9.4 Air Conditioning, Heating, Cooling and Ventilating Systems

The information in this section of the reference ABWR DCD, including all subsections, tables, and figures is incorporated by reference with the following departures and supplements.

Figure 9.4-2c Turbine Building Electrical Equipment Areas (EEA) HVAC System Diagram

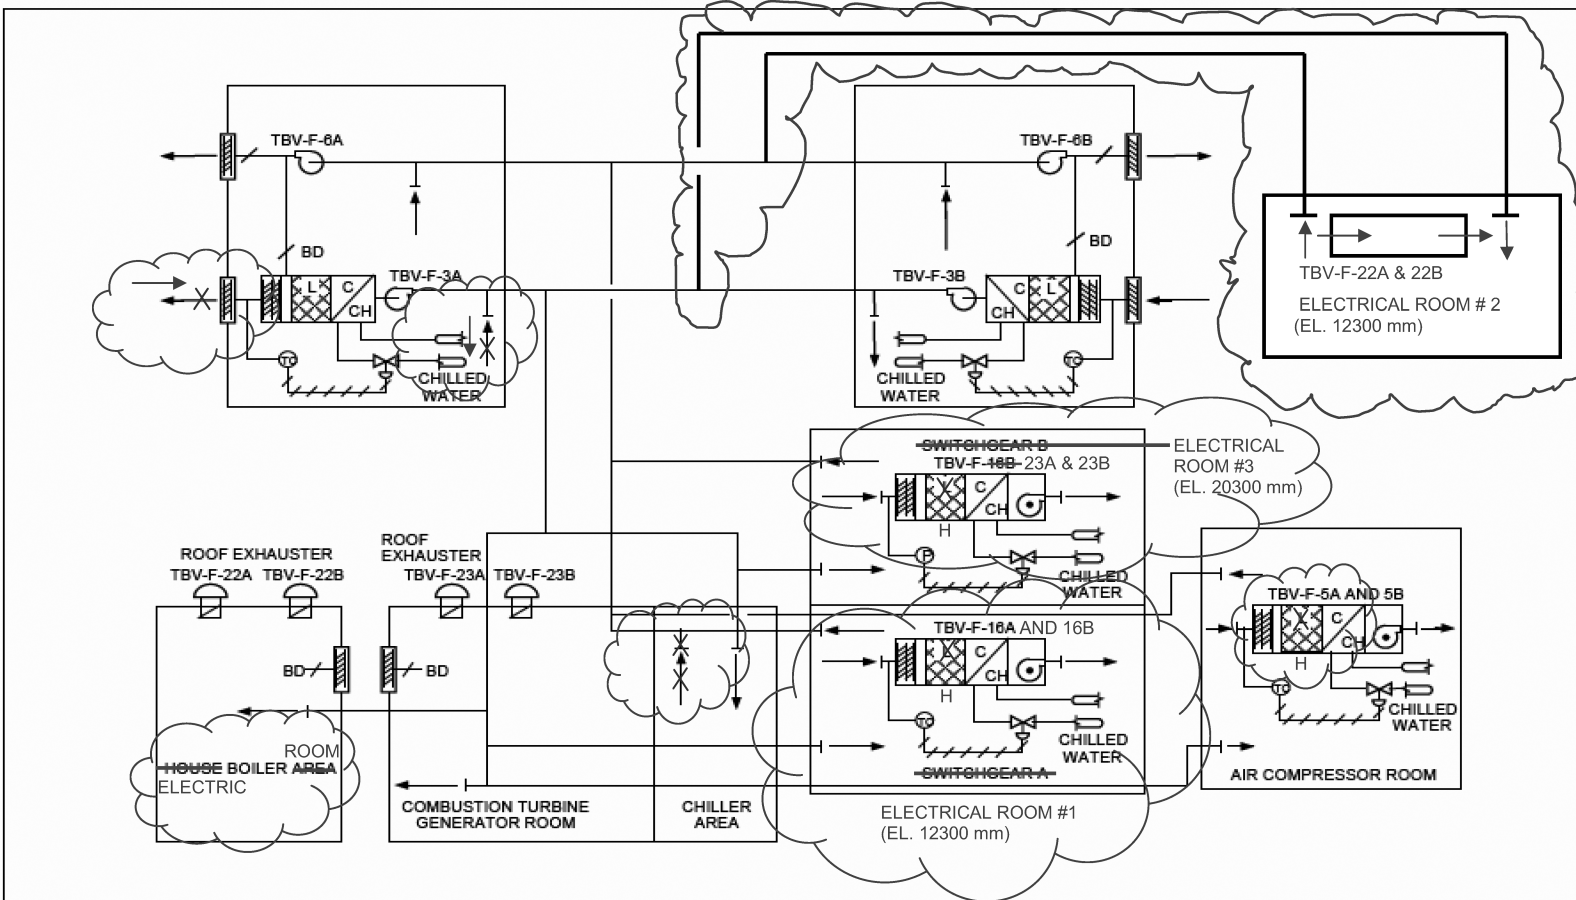
9.4.4.2.2 ~~E/B~~ EEA HVAC General Description

STD DEP 9.4-4

The ~~E/B~~ EEA HVAC schematic diagram is shown on Figure 9.4-2c.

The Electrical ~~Building~~ Equipment area HVAC System is provided with two 100% capacity air supply fans and two 100% capacity exhaust fans.

The air supply fan draws outside air through louvers, control dampers, low efficiency filters, electrical heating coils, and chilled water coils, and discharges air directly into the ~~switchgear~~ electrical rooms, chiller, combustion turbine generator, house electric boiler room and air compressor rooms. Return air Ductwork ductwork and bypass dampers are is provided to allow recirculation of air from the ~~switchgear~~ electrical rooms and chiller rooms air compressor room.

The ~~E/B~~ EEA HVAC system maintains the Electrical ~~Building~~ Equipment Areas at a positive pressure with respect to atmosphere.

Local unit coolers and/or electric unit heaters are provided as required in the ~~chiller, air compressor and combustion turbine generator room~~ high heat load areas. The unit coolers are supplied with chilled water from the Chilled Water System.
